## VALUE ENGINEERING REPORT

**Johnson Ferry Road and Glenridge Drive Connector Improvements  
City of Sandy Springs, Fulton County  
STP00-9252-00(007), PI No. 751420  
COSS Project No. T-0011**

September 27, 2011

<b>IDEA No.:</b> A-2	<b>Sheet No.:</b> 1 of 4	<b>CREATIVE IDEA:</b> Combine the dual roundabouts into a single large oval roundabout and shift the eastern roundabout approximately 75 feet to the west.
-------------------------	-----------------------------	--

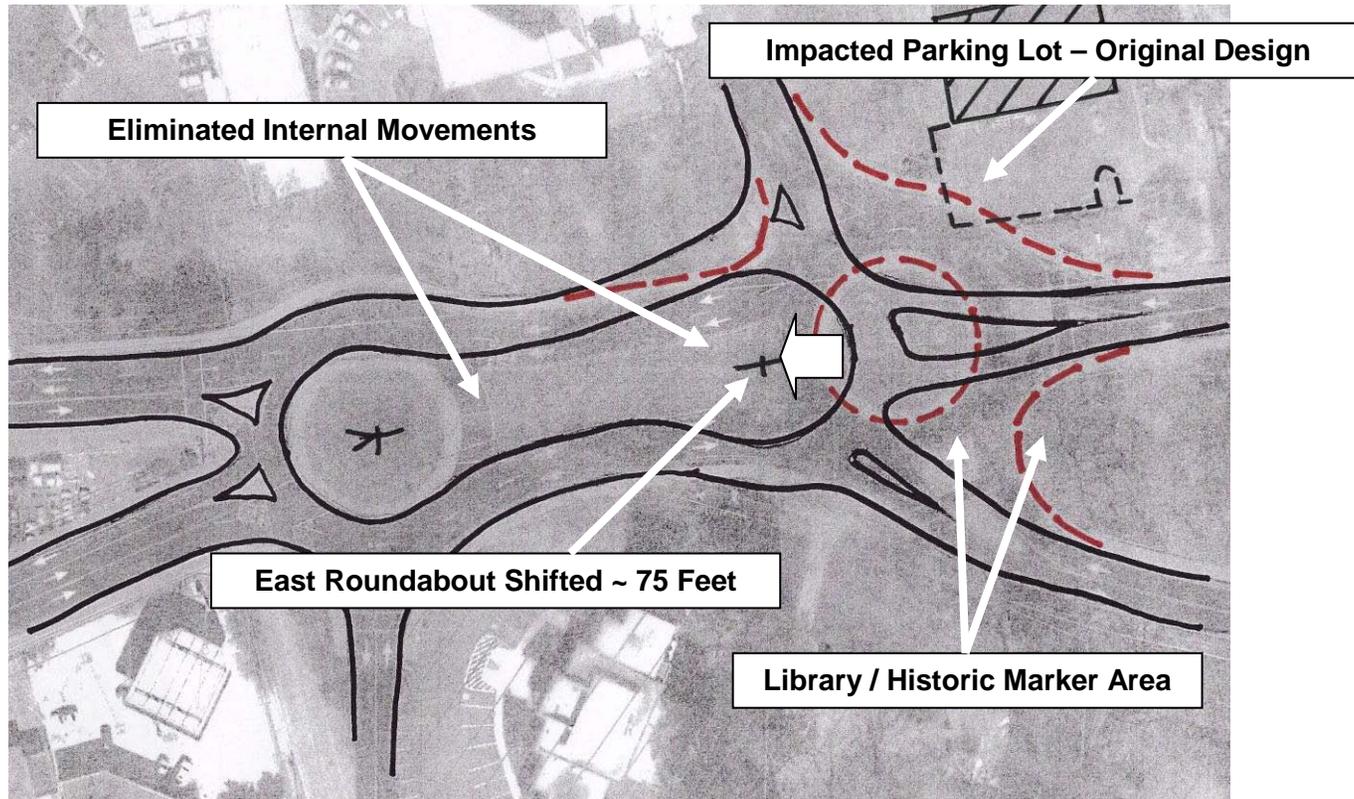
The original design would construct two roundabouts on the eastern end of the project. One would be located at Boylston Drive and the second one at the Johnson Ferry Road / Mount Vernon Highway split. The northeastern quadrant of the eastern roundabout encroaches on the parking area (requiring up to 5 spaces) of an adjacent business. It also requires R/W from the Library and the relocation of a Historic Marker.

This recommendation would consolidate the two roundabouts by closing the two inner circular turning movements and shifting (to the west) the eastern roundabout approximately 75 closer to the other roundabout.

Consolidating the roundabouts will eliminate the damages to the existing commercial parking area. It will also shift the driveway from this business further away from the Mount Vernon Highway entrance into the roundabout. Shifting the roundabout to the west will provide more space at the library quadrant, potentially saving the historic marker and creating a pocket park to better display it. The marker will still have to be protected and / or temporarily relocated during construction.

Consolidating the roundabouts will keep the same general alignments of the eastern approaches of Johnson Ferry Road and Mount Vernon Hwy as the original design.

Idea No.: A-4  
Client: City of Sandy Springs, GDOT  
Sheet 2 of 4

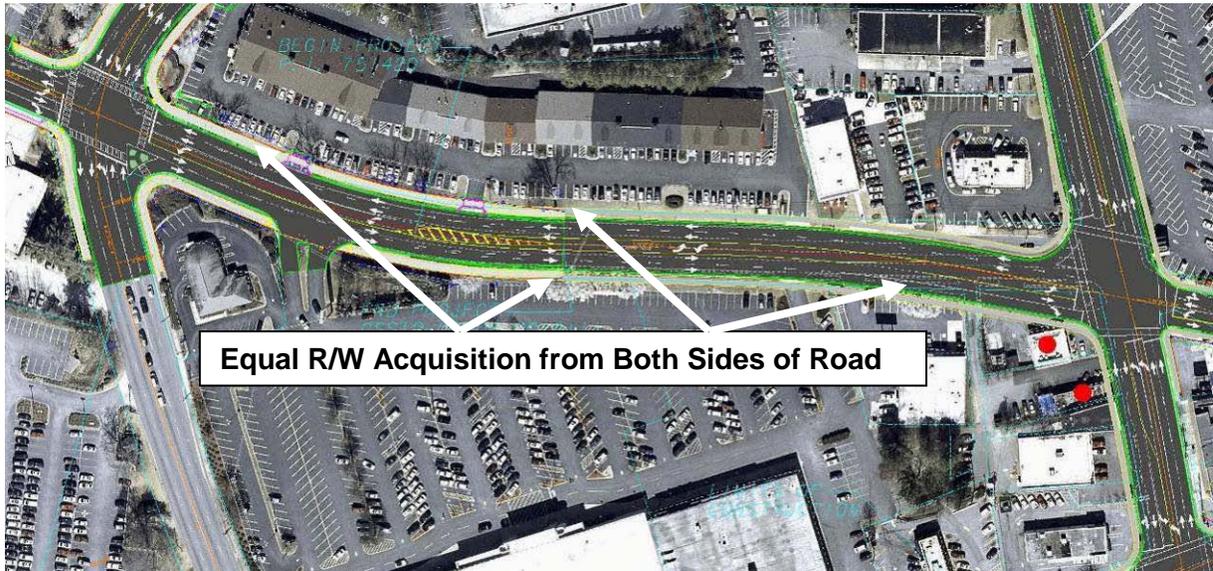
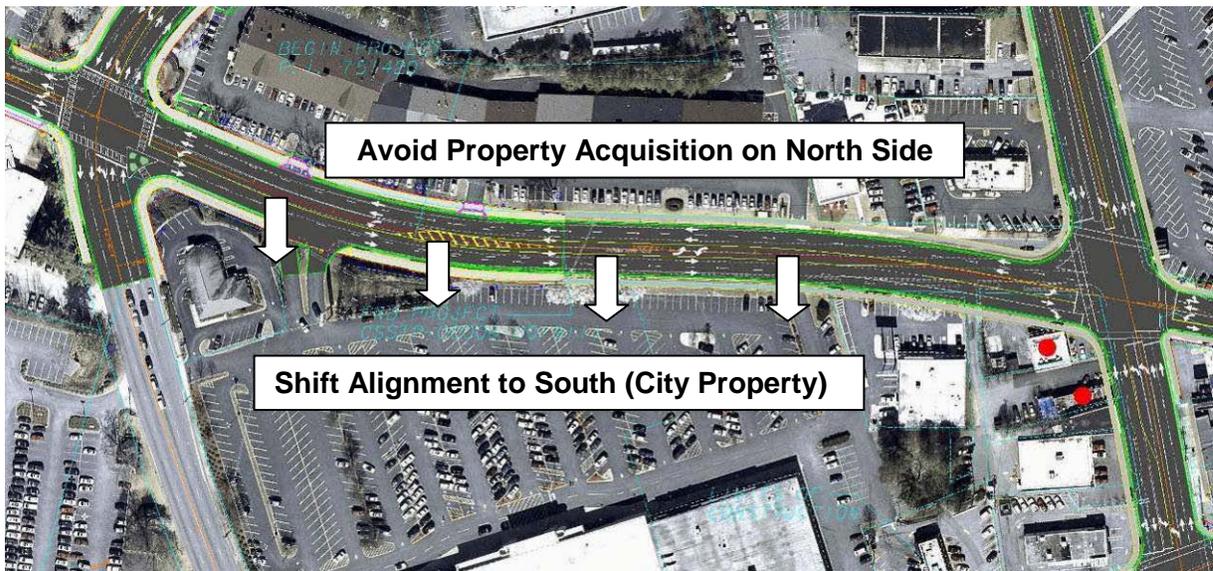
The original concept proposes an alignment on Johnson Ferry Road that impacts parcels on the north and south side of the road in the vicinity of the Target shopping center. Much of this shopping center has been acquired by the City of Sandy Springs with the remaining parcels to be acquired in the future. The City will construct a new City Hall on this property.

The revised concept recommends shifting the Johnson Ferry Road alignment to the south so only parcels on the south side of the road are impacted.

The function of improvements to Johnson Ferry Road is to reduce congestion and provide improved pedestrian facilities on both sides of the road. The original alignment requires the acquisition of R/W from both sides of the road. The City of Sandy Springs has recently purchased the Target shopping center for development as a new city hall.

Shifting the Johnson Ferry Road alignment to the south eliminates property impacts to the business on the north side. Not acquiring R/W from the north side will also eliminate the need to remove the large trees along the road.

Acquiring all the necessary R/W from the south side (an estimated 5-8 feet of additional R/W) of the roadway should not significantly impact the City's site plan for this area. The revised concept will result in R/W cost savings since the City is acquiring the R/W for this project and City owned property will not have to be acquired.

Idea No.: A-8  
Client: City of Sandy Springs, GDOT  
Sheet 2 of 4

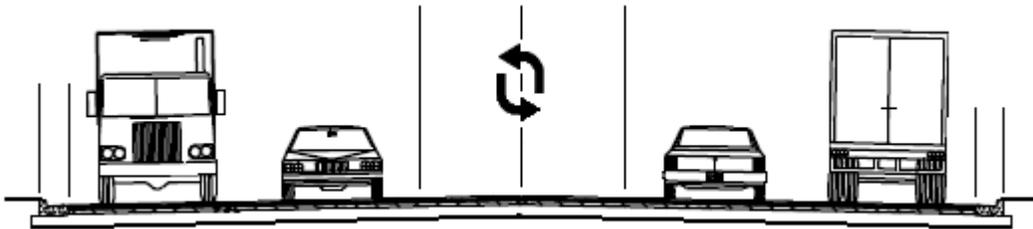
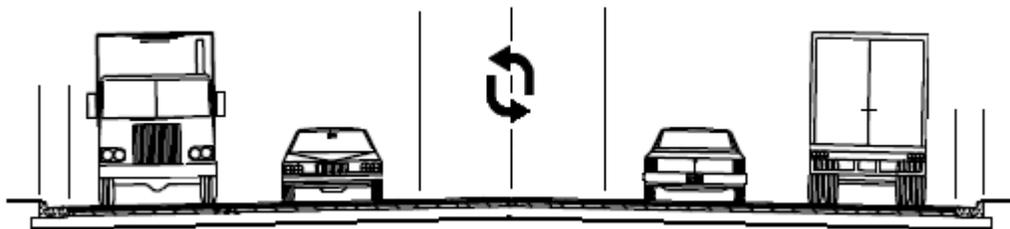
The original concept proposes to install a 14-foot-wide center turn lane on Johnson Ferry Road between Sandy Springs Circle and Roswell Road. All other center and left turn lanes throughout the project area are less than 14 feet wide.

This recommendation would revise the center lane concept and install a 12-foot-wide center turn lane on Johnson Ferry Road between Sandy Springs Circle and Roswell Road.

The original concept proposes a left turn lane width of 12 feet from Johnson Ferry Road WB to Roswell Road SB on the east side of Roswell Road. The originally proposed left turn lane from Johnson Ferry Road WB to Sandy Springs Circle SB included in the adjoining project also has a width of 12 feet. The reduction in width from 14 feet to 12 feet for the short section of Johnson Ferry Road from Sandy Springs Circle to Roswell Road is consistent with the adjoining sections and will result in R/W savings.

<b>IDEA No.:</b> A-11	<b>Sheet No.:</b> 1 of 5	<b>CREATIVE IDEA:</b> Acquire all the R/W for the proposed six-lane Roswell Road section & the intersection approach sections from the west side of the existing roadway.
--------------------------	-----------------------------	---

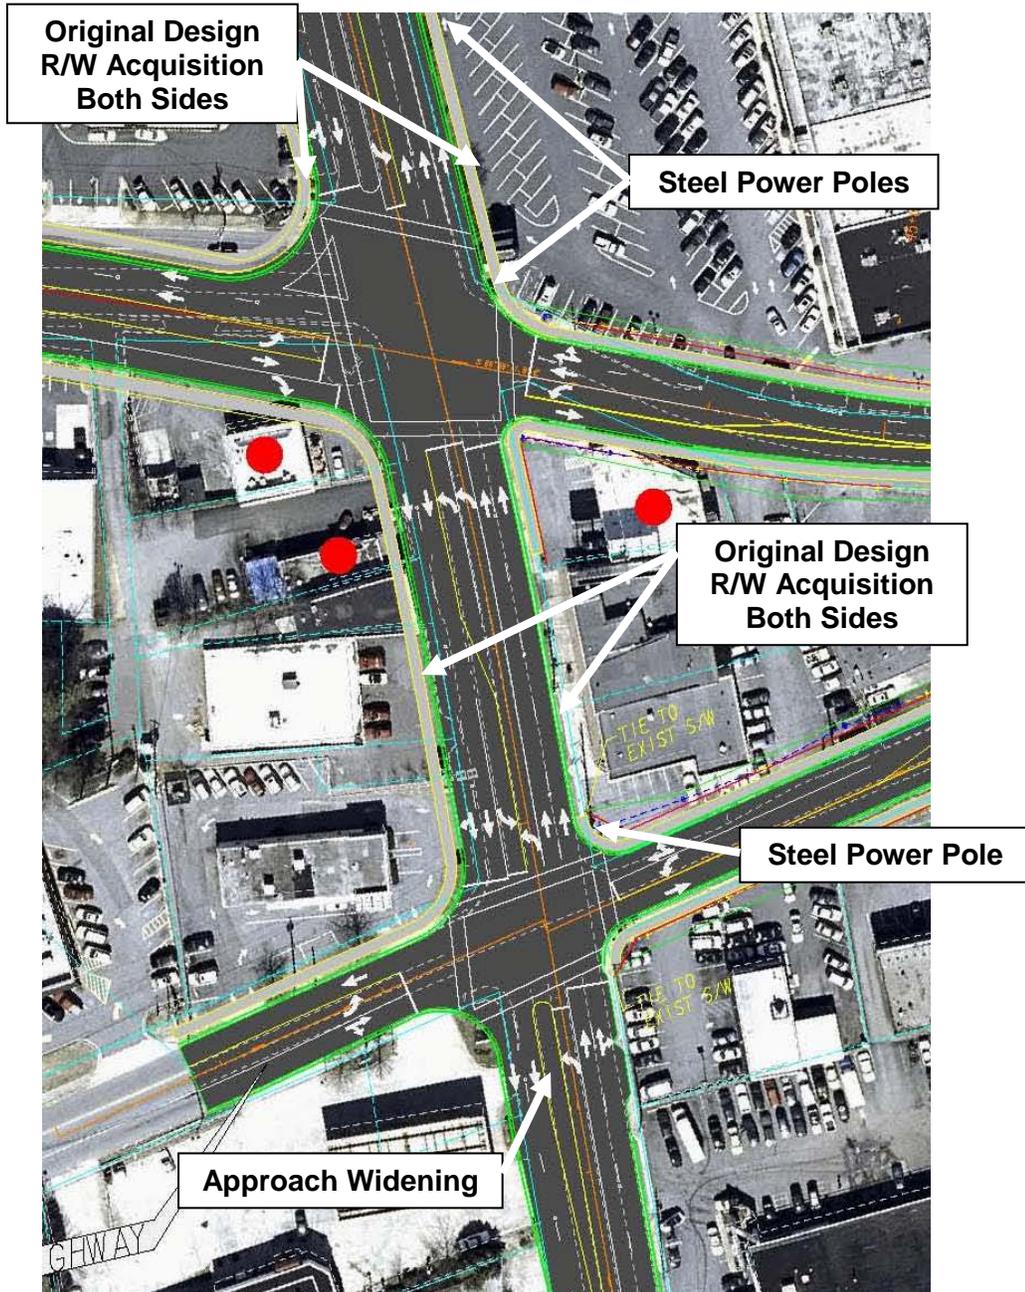
The original design widens Roswell Road from five lanes to six lanes between Johnson Ferry Road and Mount Vernon Highway. It also widens the NB and SB approaches to the new six-lane section. The 100 scale layout concept shows that equal amounts of R/W would be acquired from both sides of Roswell Road to add the additional lane. This concept also requires the acquisition / relocation of two parcels on the west side and one acquisition / relocation on the east side.

Two electrical utility lines are located immediately adjacent to the existing east Roswell Road curb and gutter. One line uses large steel poles and the second line uses wood poles. Three steel poles are located north of Johnson Ferry Road, one steel pole is in the NE corner of the Roswell Road / Mount Vernon Highway intersection, and one steel pole is south of Mount Vernon Highway.

Eliminating any Roswell Road widening on the east side will allow the two electrical utility lines to remain in-place. This recommendation would allow sidewalk construction and widening around the existing poles. Eliminating the need to relocate these utilities will reduce the project cost and reduce project development / construction time.

Idea No.: B-2.1  
Client: City of Sandy Springs, GDOT  
Sheet 2 of 5

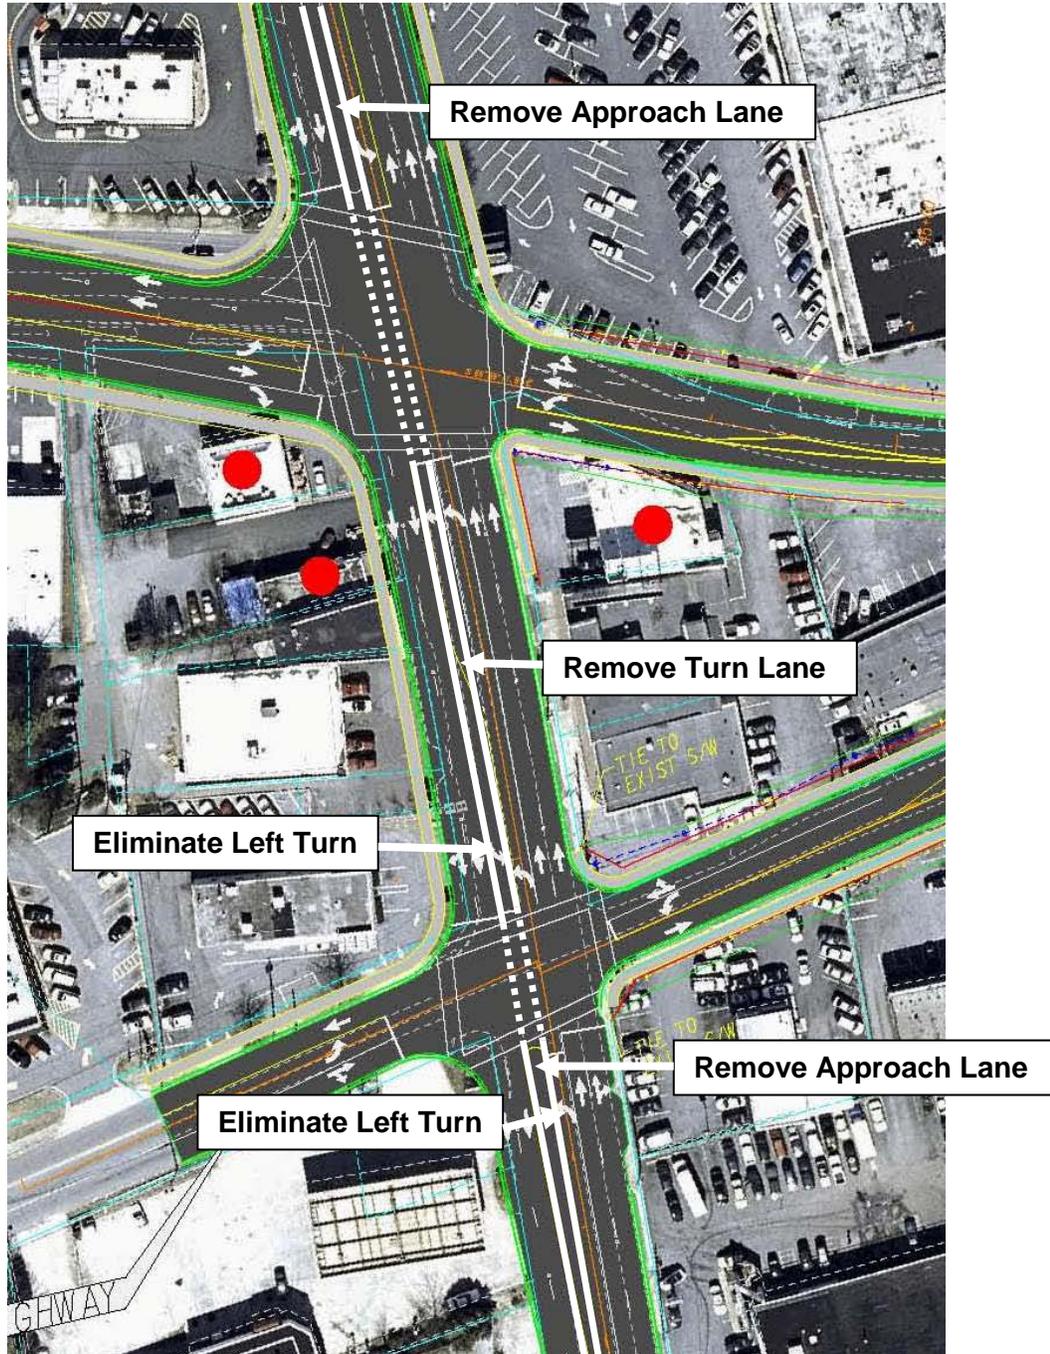
The elimination of this additional turn lane requires prohibiting SB left turns at Mount Vernon Highway so the entire center turn lane can function as a NB left turn lane at Johnson Ferry road. Eliminating this 250-foot Roswell Road six-lane section and its required lane shift approaches to the north and south will reduce the roadway footprint and its associated R/W impacts and requirements.

This concept also prohibits the NB Roswell Road left turn at Mount Vernon Highway so this area can be used for additional storage for the NB Roswell Road left turn at Johnson Ferry Road. It is assumed that most of the left turning vehicles at Mount Vernon Highway are ultimately destined to use Johnson Ferry road and are turning at Mount Vernon Highway to shortcut the left turn at Johnson Ferry Road.

Eliminating left turns in both directions at Mount Vernon Highway may require some additional signage and monitoring, however, it should improve the overall LOS and intersection operations at both locations.

**NOTE:** This recommendation does not address the issue of acquiring R/W on the east side of Roswell Road and its impact on the large utility poles next to the existing curb and gutter line. This issue is discussed in Recommendation A-11.

Idea No.: I-6  
Client: City of Sandy Springs, GDOT  
Sheet 2 of 5

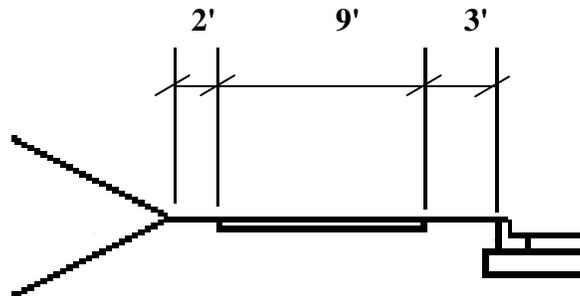
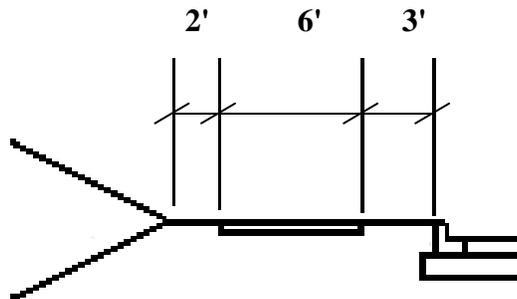
The function of the sidewalks is to provide pedestrian access and connection to existing sidewalk sections adjacent to the project. This function can be accomplished through the installation of 6-foot-wide sidewalks in lieu of 9-foot-wide sidewalks. Implementation of the revised concept will result in significant savings in right-of-way.

## Original Sidewalk Concept - 14-Foot Shoulder Curb & Gutter, 3-ft Grass, 9-ft Sidewalk & 2-ft Grass

## VE Sidewalk Concept - 11-Foot Shoulder Curb & Gutter, 3-ft Grass, 6-ft Sidewalk & 2-ft Grass
